Is the Beachen Court Development in the Cairngorms National Park the national “go to” place for water technology?

Design Problems

Plan1: Design drawing proposing siting the SUDS pond on the 1:4 slope

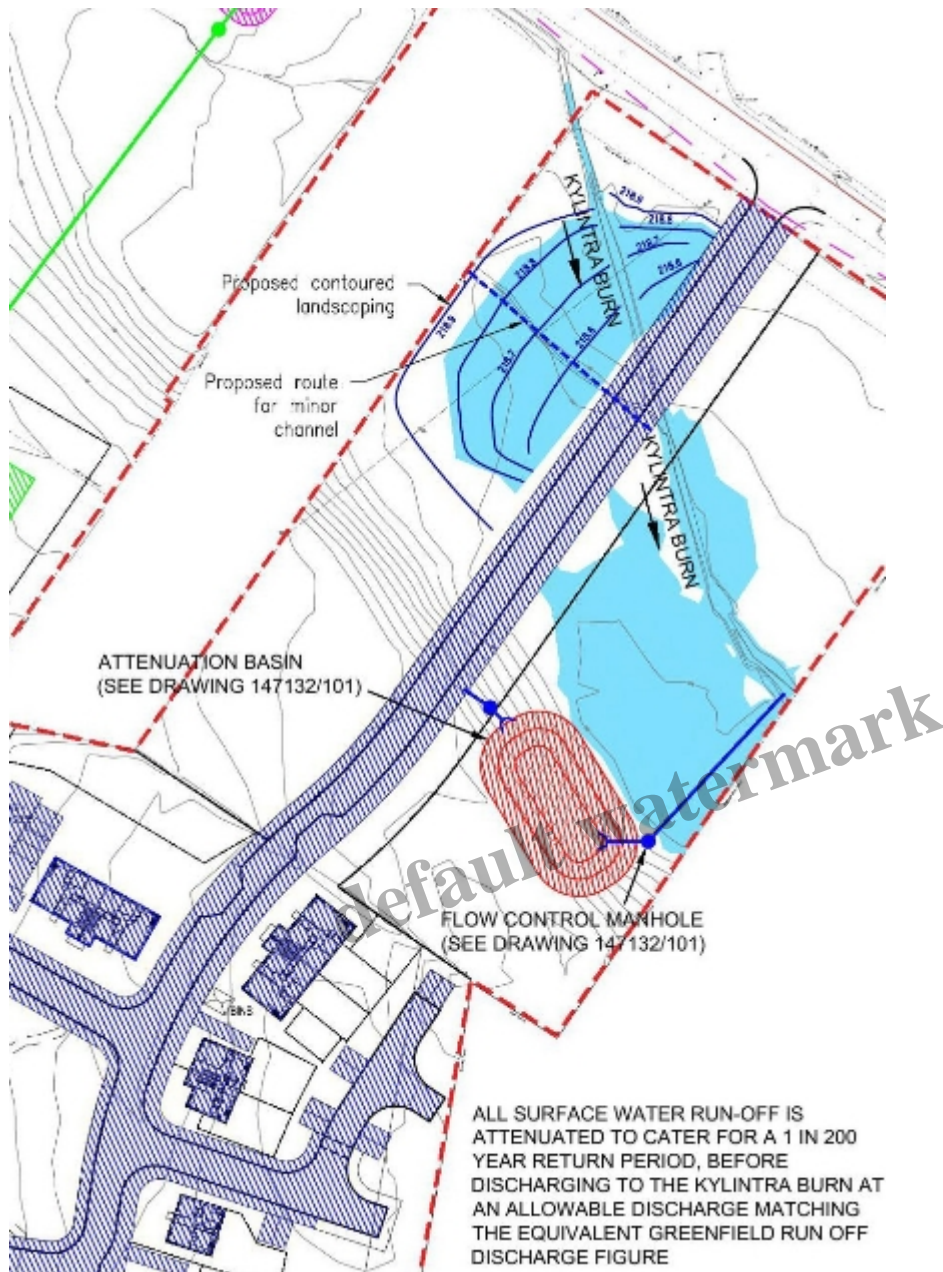
The initial engineering drawing submitted to CNPA around March 2016 in support of the planning application contained several serious design issues e.g. it proposed that a SUDS pond, capacity some 500m³ be located in the middle of the 1:4 slope of river terrace south of the floodplain – a ridiculous proposition:

The dimensions of the proposed pond were also incorrect, far too small to provide the stated design capacity. OK, the design engineer made some dreadful mistakes but, just as concerning, when the developer submitted this drawing in support of his application the CNPA as Planning Authority, apparently without thought, put it out for public consultation. CNPA will say it's not their job to question design when there is a statutory consultee to make comments but the faults with the pond were so obvious it would surely have been common sense for CNPA to address them before consultation and avoid wasting consultees' time.

Plan 2: Approved design for the relocated SUDS pond. Note the constraints of new access road, public road (Seafield Avenue), The Dulaig driveway and the Kylintra Burn floodplain

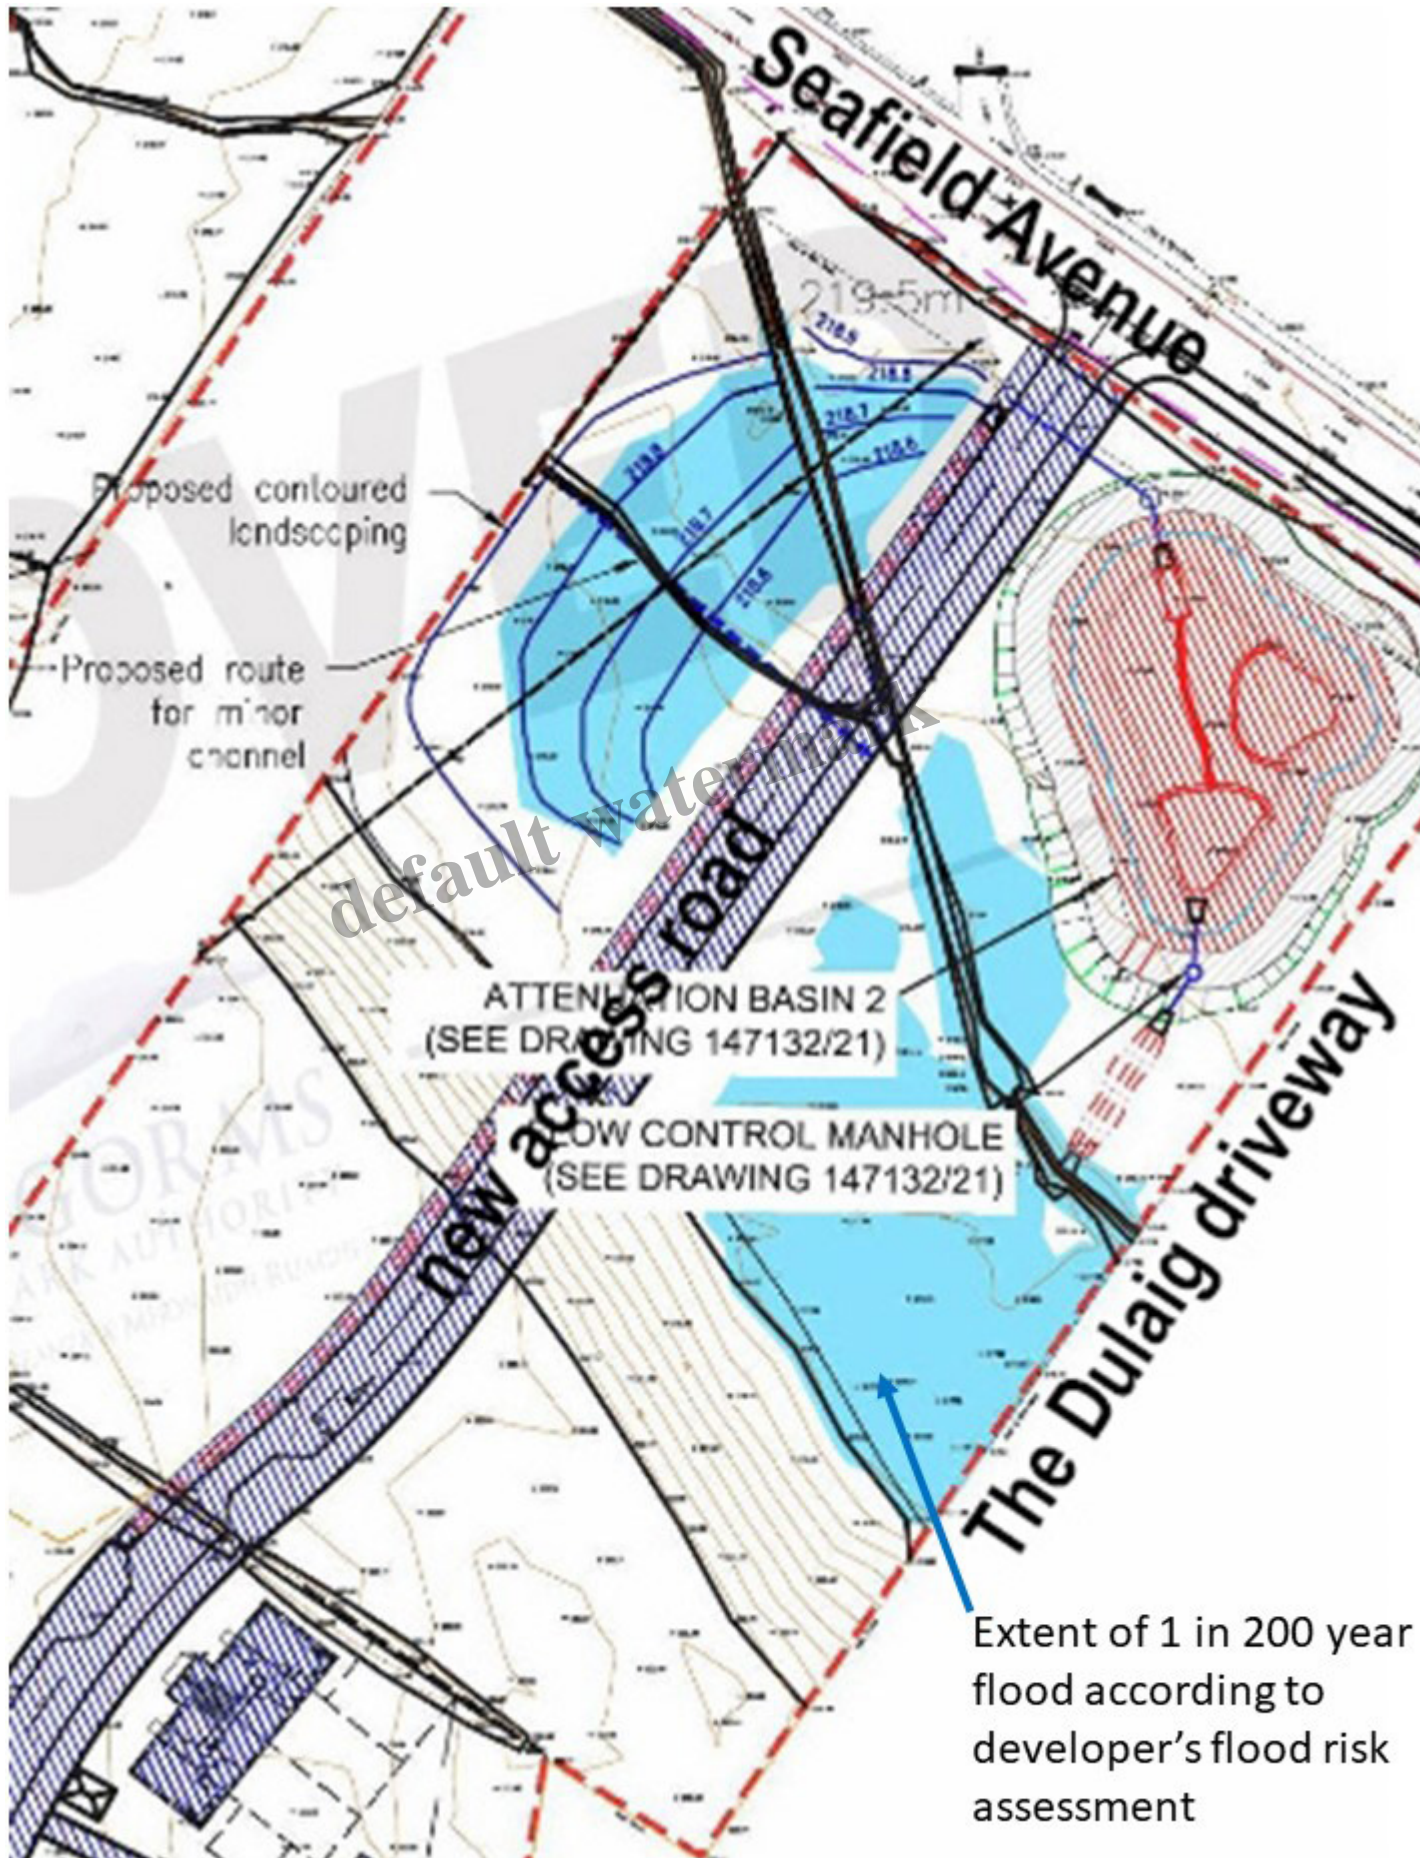
Following criticism on consultation the plan was amended to show the SUDS pond relocated onto the floodplain area of the Kynlra Burn. The size appeared to offer the design capacity and other errors were corrected. Statutory consultees seemed relatively content with the new design which was included in the planning application approved by the CNPA Planning Committee in October 2016, however significant problems remained e.g.:-

– The size and shape of the SUDS pond is highly constrained by the new access road to the west, Seafeld Avenue to the north, the driveway of The Dulaig to the east and the flood plain of the Kynlra

Burn to the south. There is no room for manoeuvre.

Plan 3: Plan showing error in locating the SUDS pond to overlap with the required tree root protection area

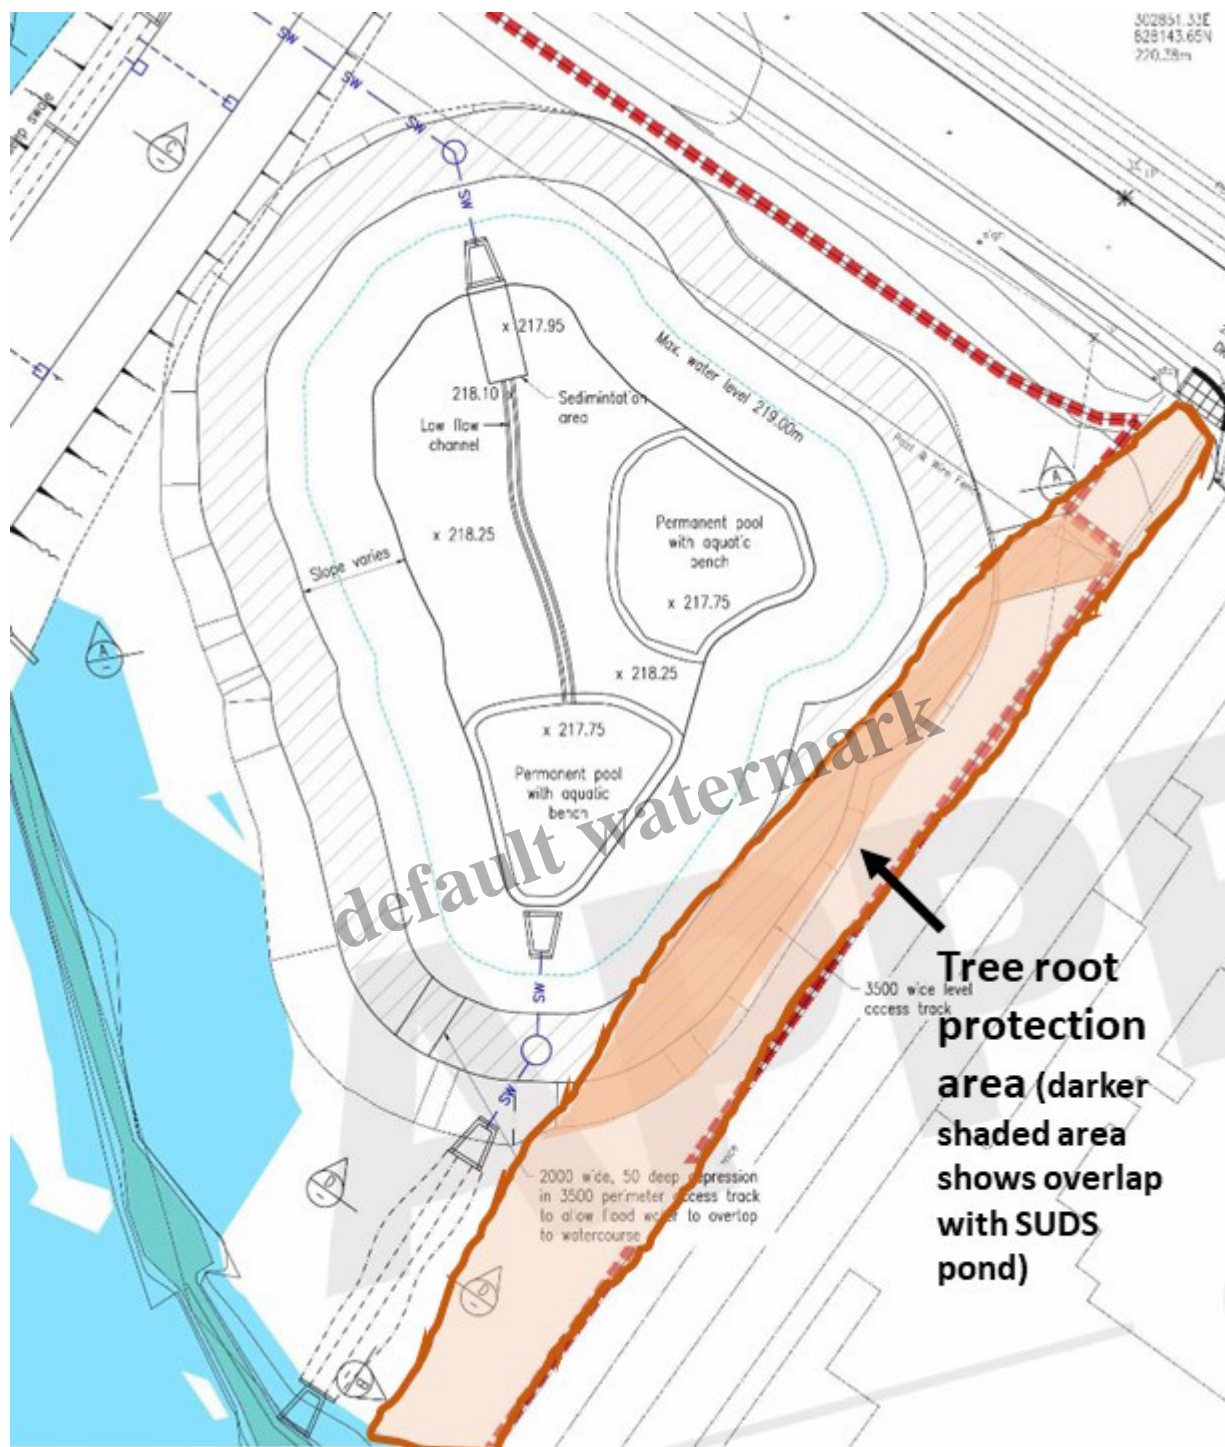
After planning permission had been granted it was discovered that the approved design completely ignored that the mature trees lining our driveway required a tree root protection area – up to 9 metres wide – which stretched into the development site. The design required the eastern embankment of the pond be built right over this tree root protection area.

The paper trail is a bit unclear but it appears that CNPA was certainly aware of the tree problem in late April 2017, just as development site work was commencing. Why was this problem not picked up earlier? In my opinion it was due to bad – or non-existent – project management and because the drawing showing the relocated SUDS pond was too schematic i.e. it shows the dimensions of the pond but not its position relative to the surrounding fixed structures. This is a learning point for the planners.

Plan 4: The approved SUDS plan overlaid with the additional unapproved fill area shown in photo 5

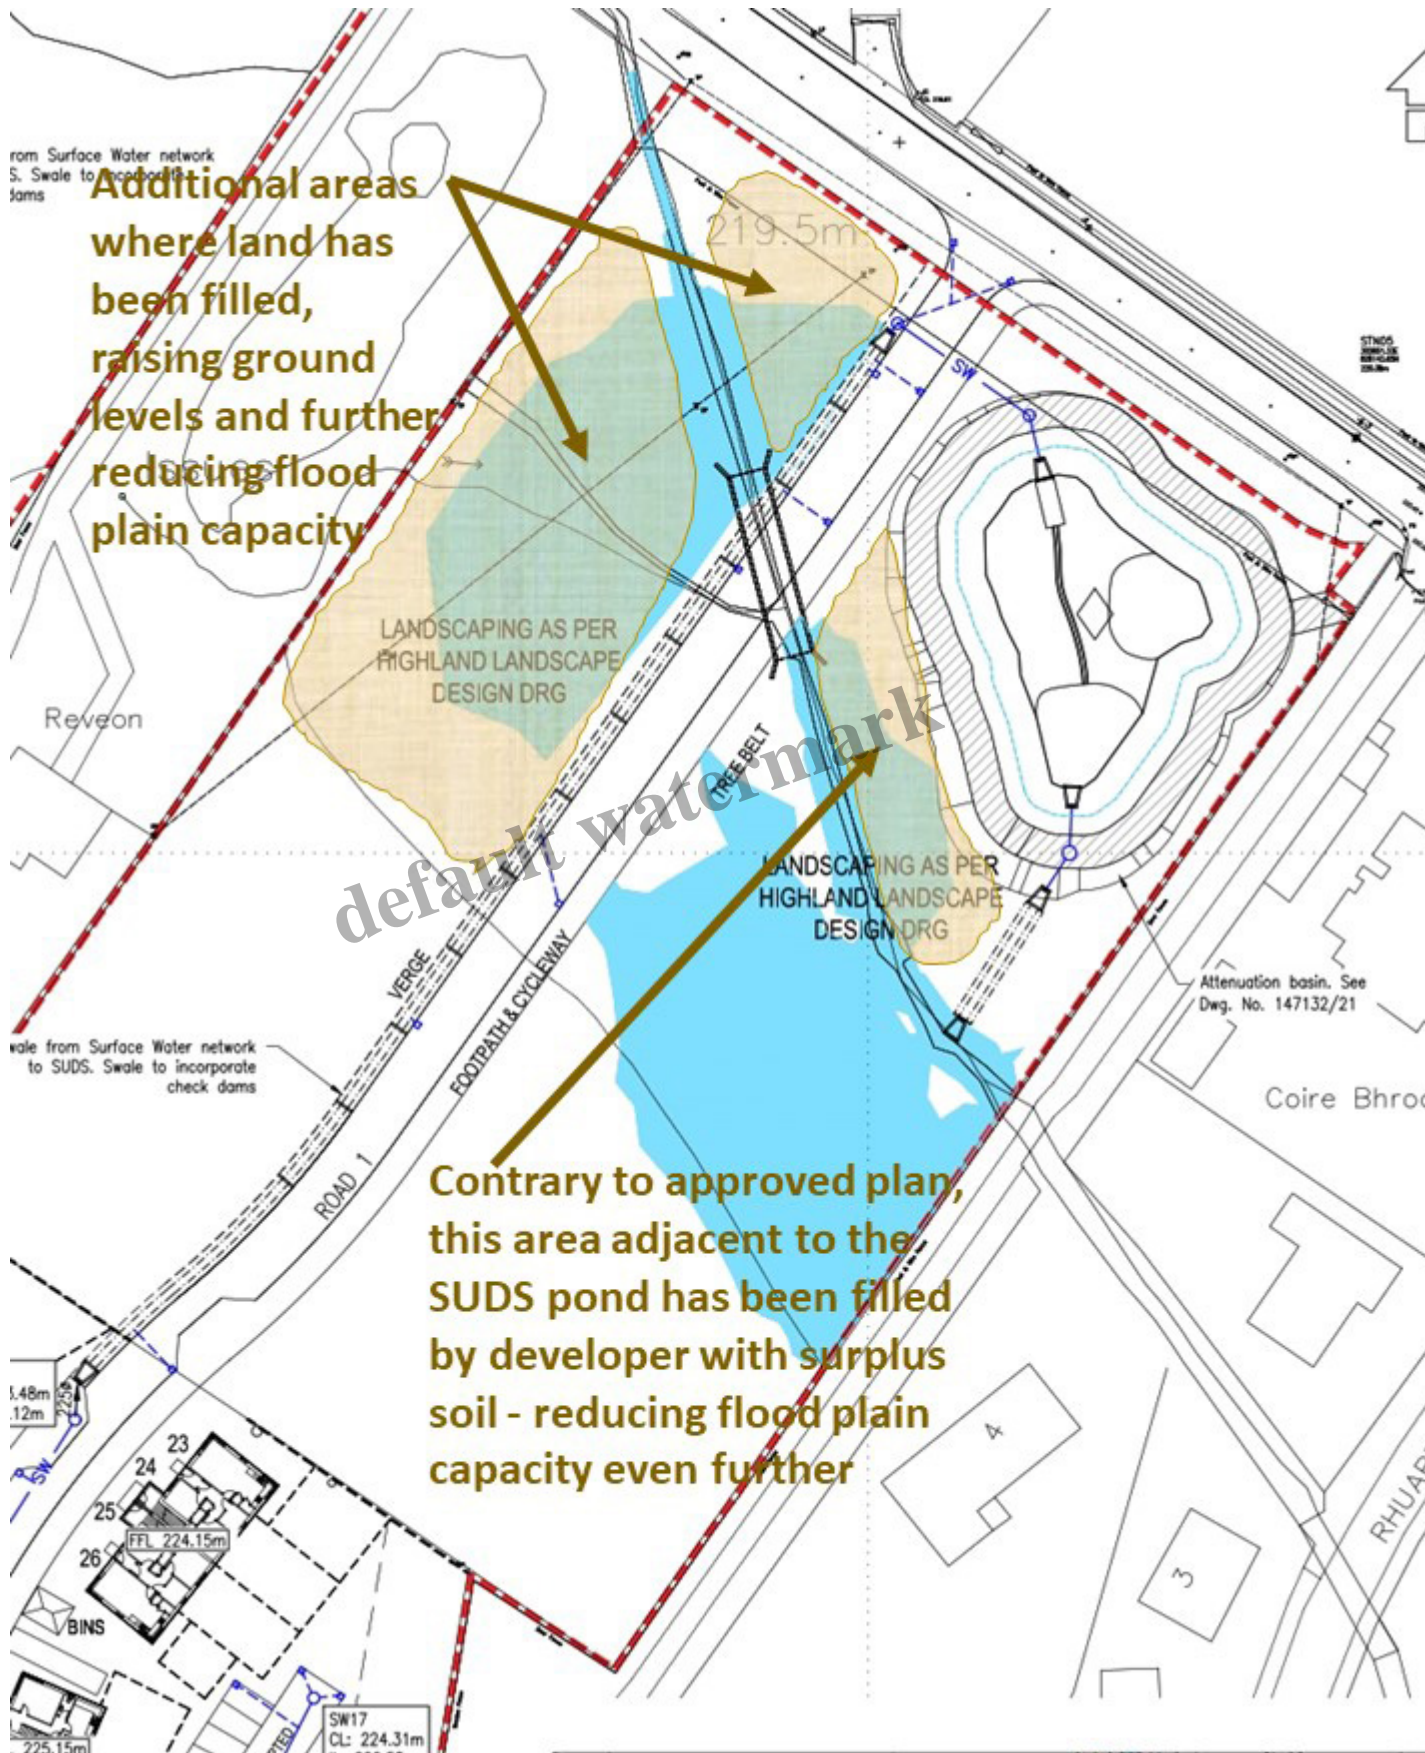
Does the SUDS pond encroach on the area of flood plain required to cope with a 1 in 200 year flood (Plan 2 above)? The Developer's Flood Risk Assessment says it does not, but I have serious doubts about this. In addition I have concerns that the as-built SUDS pond footprint, including embankments, is larger than the approved drawing and thus further encroaches on the already restricted flood plain.

Note that most of the SUDS pond footprint covers an area which had been long grass and rushes – an indicator of wetland – demonstrating it encroaches on the functioning flood plain

below which further reduces flood plain capacity.
